Wisconsin Department of Transportation

Proposal #15: 4984-08-71, WISC 2015 643
C Appleton, Lawe St
Power Canal Bridge
Local Street
Outagamie County

This is Addendum No. 01, which provides for the following:

Addendum No. 01
 ID 4984-08-71
 Revised Sheet 6
 November 24, 2015

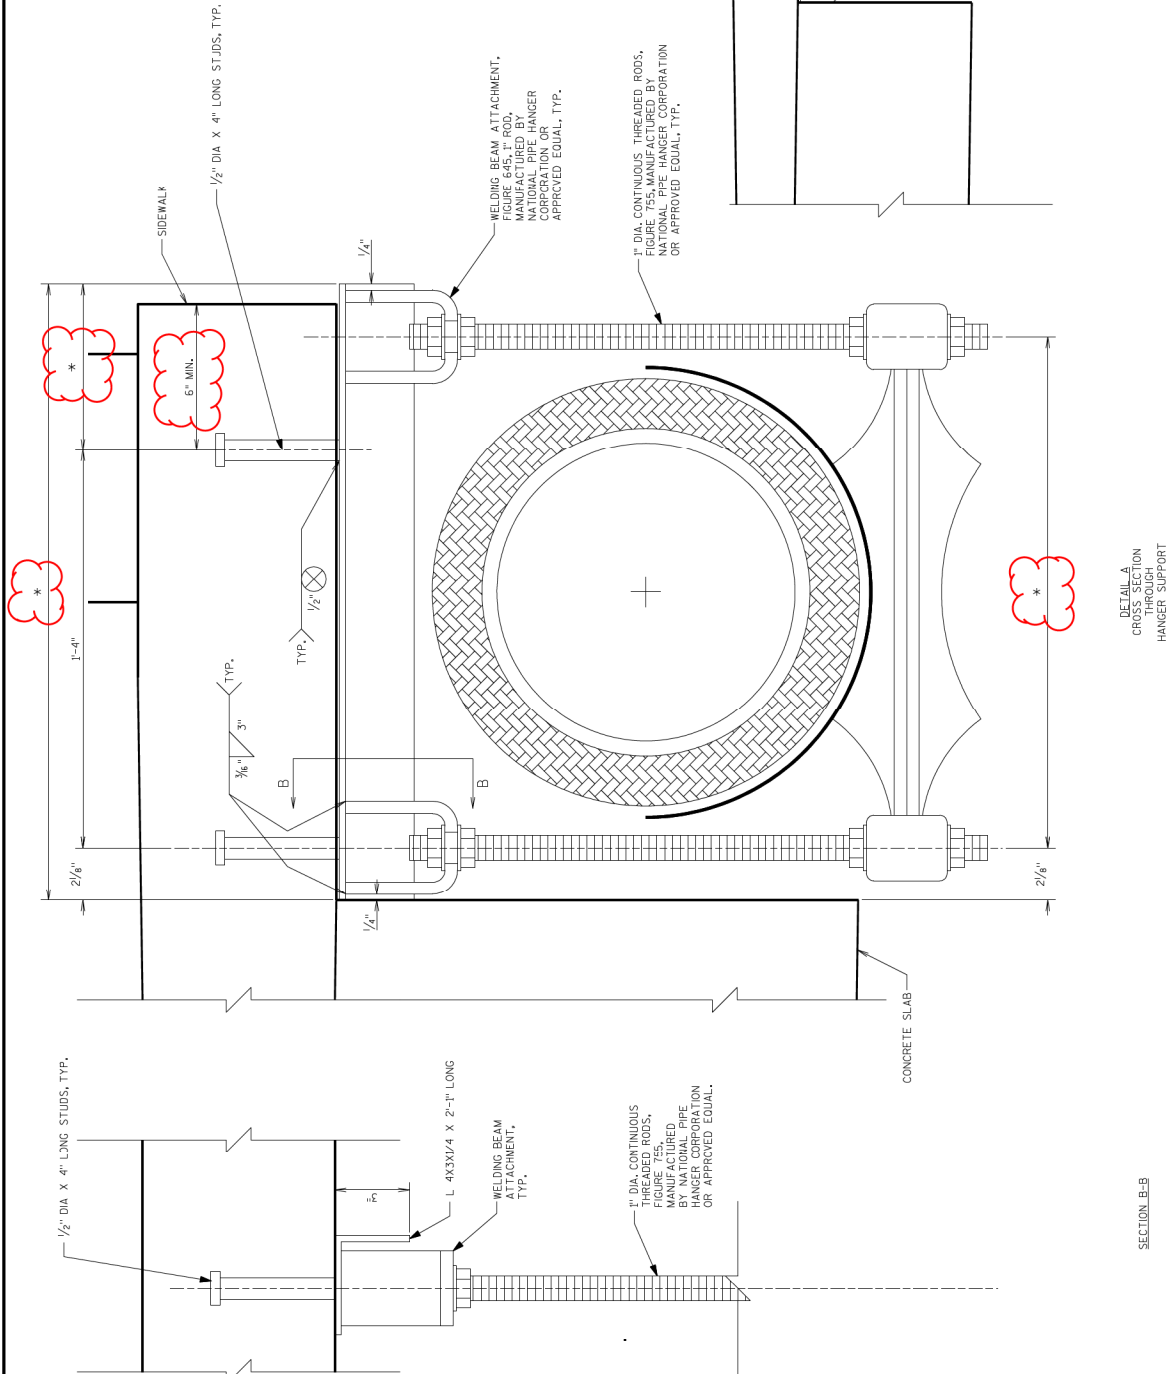
Revised Plan Sheets	
Plan Sheet	Plan Sheet Title (brief description of changes to sheet)
6	Construction Details – Watermain Hanger Assembly (changed National Pipe Hanger Corporation, Figure 260 to Anvil International, Figure 171)

ADJUSTABLE TWO-ROD ROLLER HANGER FIGURE 171. PIPE SIZE IS AS MANUFACTURED BY ANVI INTERNATIONAL OR APPROVED EQUAL.
